Fixing the List Config/Cycle Timer state machine race conditions

Re: Q-rev/D1.0 SA ballot comment I-22, 802.1 maintenance item 0319.
Following up Alon Regev's work.

Mick Seaman
mickseaman@gmail.com

Net mgmt./List Config/Cycle Timer/List Execute configuration—current (1)

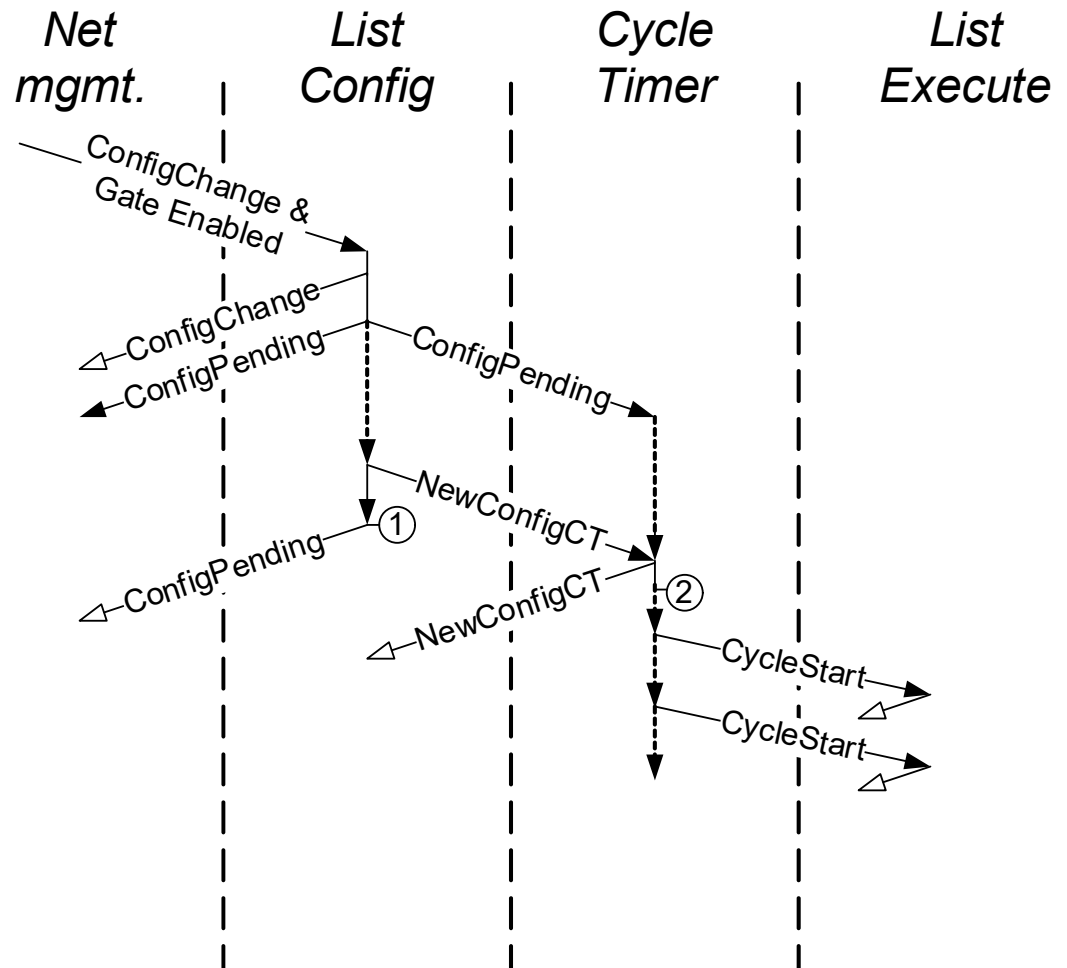
Configuration change race

State machines do not constrain the execution order of List Config:UPDATE_CONFIG and Cycle Timer:SET_CYCLE_START_TIME, (1) and (2) in the Figure.

(1) clears ConfigPending, which affects setCycleTimer() processing at (2).

SetCycleStartTime() can be executed by toggling GateEnabled, so a change to clearing ConfigPending in the Cycle Timer machine needs to be conditional. Maintenance item 0319 proposes an extra state to clear the variable, but also clears it on one condition in the procedure.

Net mgmt./List Config/Cycle Timer/List Execute configuration—current (2)

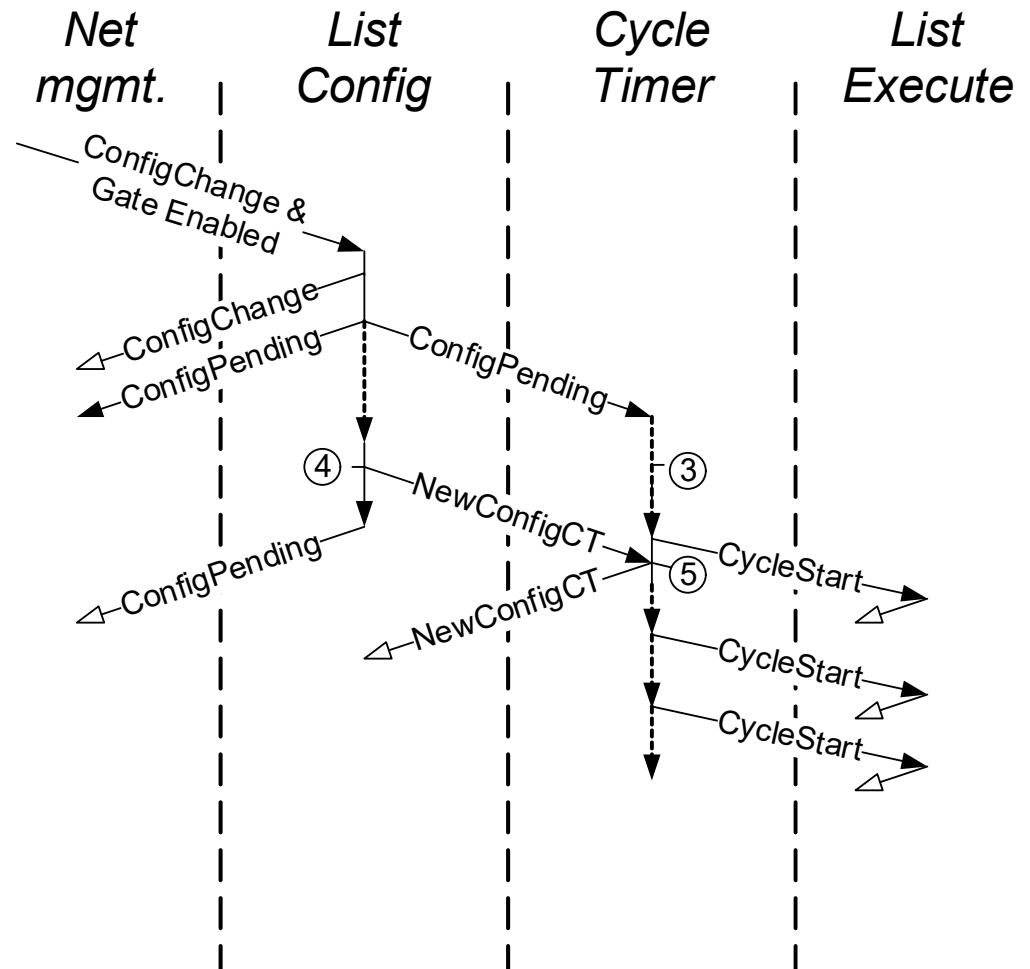
Another race?

In the Cycle Timer machine, if ConfigPending and ConfigChangeTime is no later than CurrentTime + OperCycleTime + OperCycleTimeExtension then SetCycleStartTime case (d) delays the next CycleStartTime to ConfigChangeTime.

State List Config:UPDATE.. is entered when ConfigChangeTime ≤ CurrentTime and Cycle Timer:START_CYCLE is entered when CycleStartTime ≤ CurrentTime, i.e. at the same time following case (d) above. Execution of the two states is mutually exclusive, but either can precede the other. List Execute:NEW_CYCLE can be entered as soon as START_CYCLE has executed, so can precede List Config:UPDATE..., and can take the first item from the old OperControlList before that list is updated.

A better Cycle Timer machine (1)

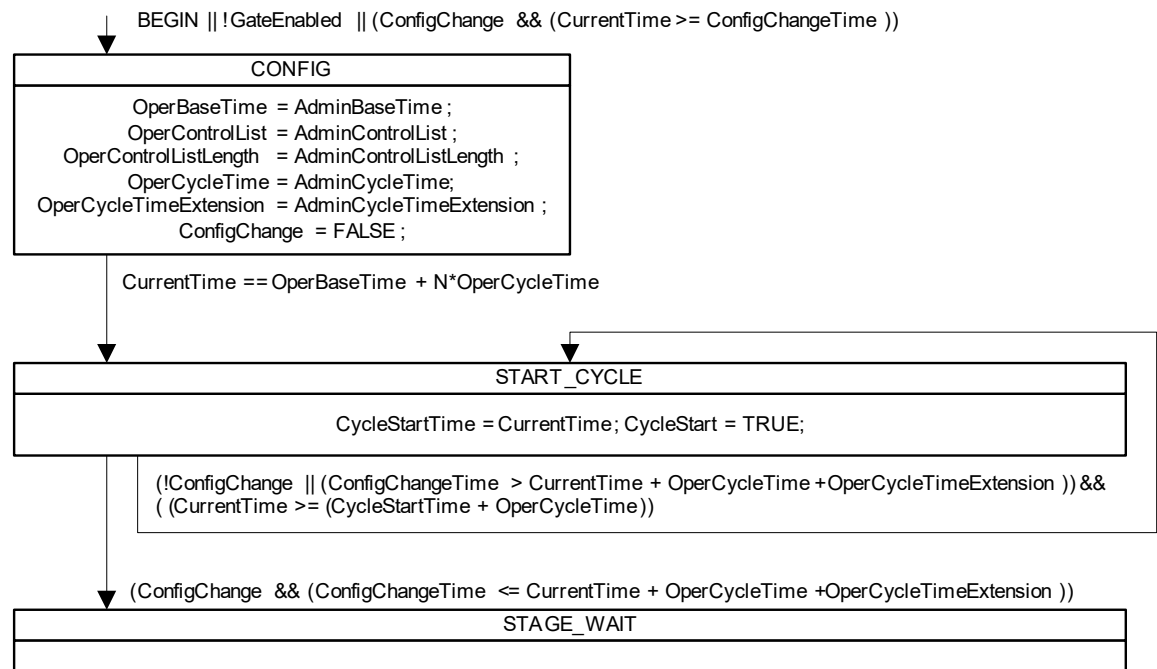
Don't use SetCycleStartTime() to test Config Pending and hide the significant state difference between:

- continuing an established set of cycles (with one set of Oper .. parameters)
- setting up a new, possibly delayed set of cycles with a new set of Oper.. parameters

Don't split the logic for a new set of cycles between machines. Add update functionality to the Cycle Timer, make the update conditions explicit [no need for SetCycleStartTime()]. All List Config (if kept) has to do is calculate Config Change Time. List Execute machine unchanged.

Current curiosities:

1. Oper.. variables only set when GateEnabled, race condition on start up [removed].

2. Cycle start skipped when one more cycle would fit before ConfigChangeTime.

A better Cycle Timer machine (2)

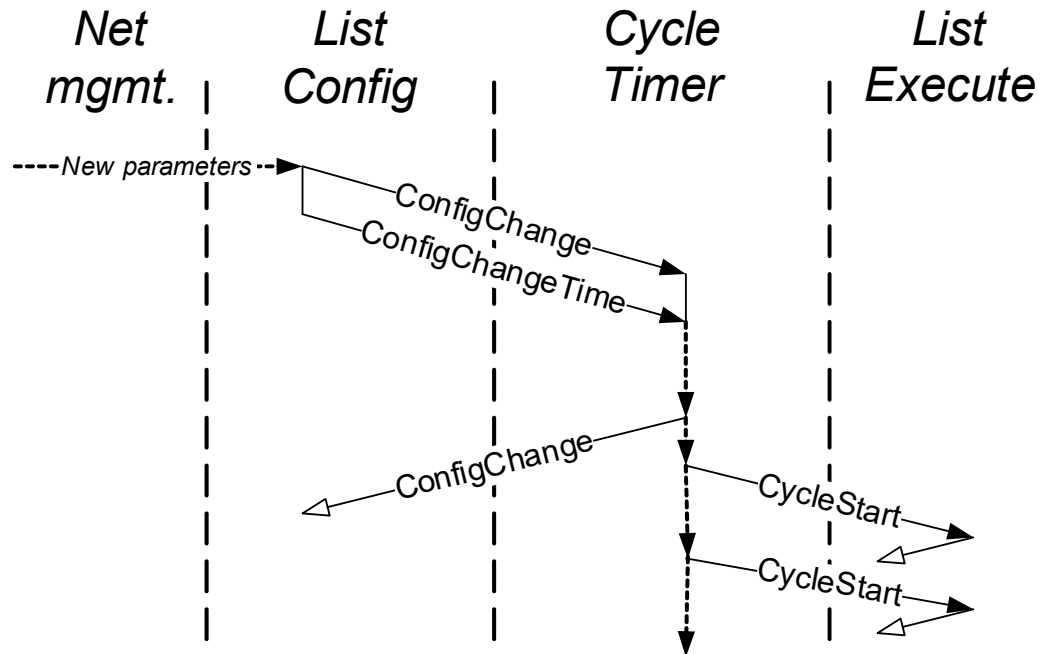
ConfigChange Time calculation, and ConfigChange set as a direct procedural result of a network management update of list parameters (no List Config machine required).

CycleTimer machine clears (resets) ConfigChange when the Oper.. variables have been updated with the new Admin variables [job done].

No need for ConfigPending or NewConfigCT.

But there are a lot of references to ConfigPending in Q-Rev/D1.0, including throughout the management clauses. Need to be sensitive to current implementations and users, *sometimes fixing a mistake is a mistake*.

Proposed Cycle Timer machine

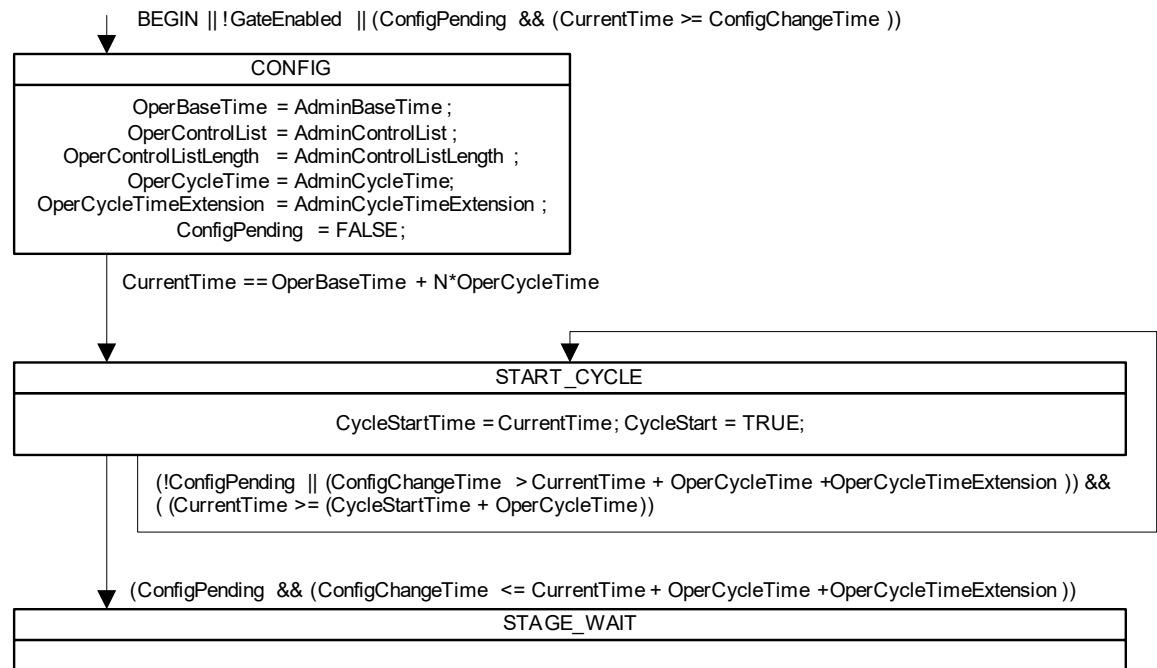
As on Slide 6, but substituting ConfigPending for ConfigChange. SetCycleStartTime() procedure (8.6.9.1.1) no longer used, move Notes to 8.6.9.1. Trivial changes to 8.6.9.4.8, 8.6.9.4.12, and 8.6.9.4.21—refer to the state machine, not the procedure.

Curiosity left unchanged:

1. Cycle start skipped when one more cycle would fit before ConfigChangeTime.

Net mgmt./List Config/Cycle Timer/List Execute configuration—proposed

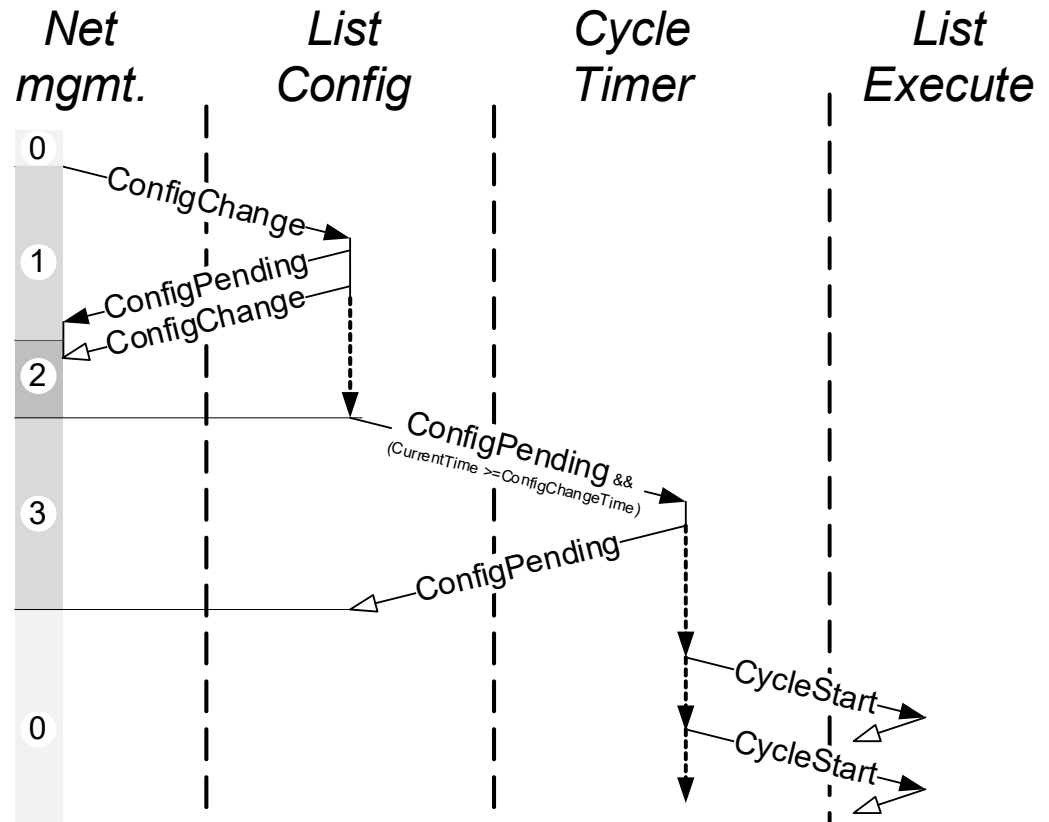
States/config progress:

0: !ConfigChange && !ConfigPending && (CurrentTime >= ConfigChangeTime)

List is executing, or will start executing at net possible Cycle Start time (or !GateEnabled)

1: ConfigChange && !ConfigPending

Probably not observable. List Config machine will set ConfigPending if !BEGIN,

2: ConfigPending && (CurrentTime < ConfigChangeTime)

Update of Oper variables is pending.

3: ConfigPending && (CurrentTime >= ConfigChangeTime) but Oper.. variables not updated

Probably not observable.

Proposed List Config machine

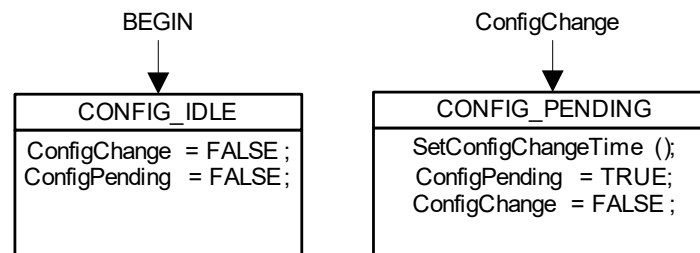
Trivial accompanying changes to 8.6.9. pg 229 line 19, and through the subclauses of 8.6.9.4 (substitute Cycle Timer state machine for references to List Config state machine).

Curiosities:

1. Was not possible to configure the Oper.. variables before enabling Gates [removed]. This change has no effect on the use of gates when !GateEnabled since the List Execute machine will hold them in the AdminGatesState anyway.

2. ConfigChange not initialized by any machine [now shown as initialized by this machine].

Proposed state machine overview (Figure 8-18)

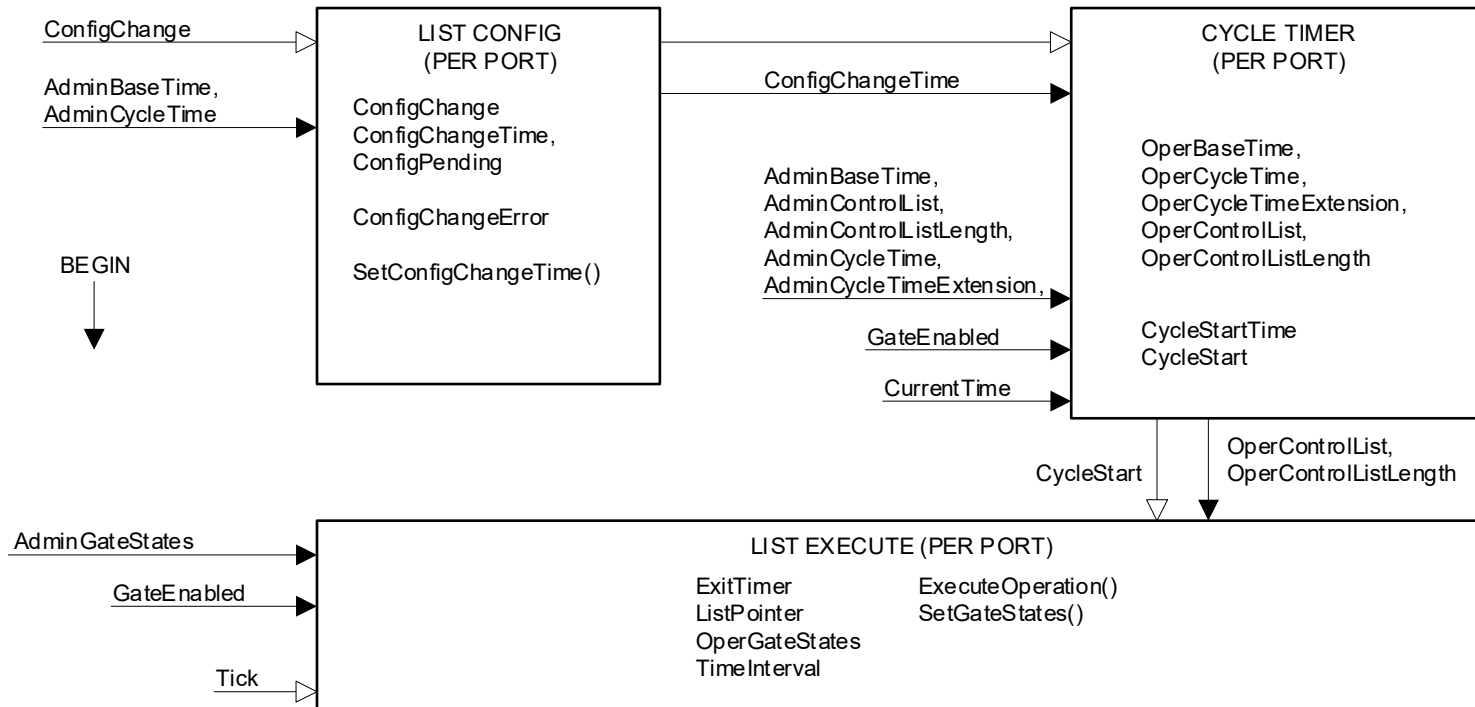
Remove NewConfigCT. Variables that are shown as communicating between machines are only shown inside their 'home' machine, i.e. the machine that is responsible for their initialisation on BEGIN.
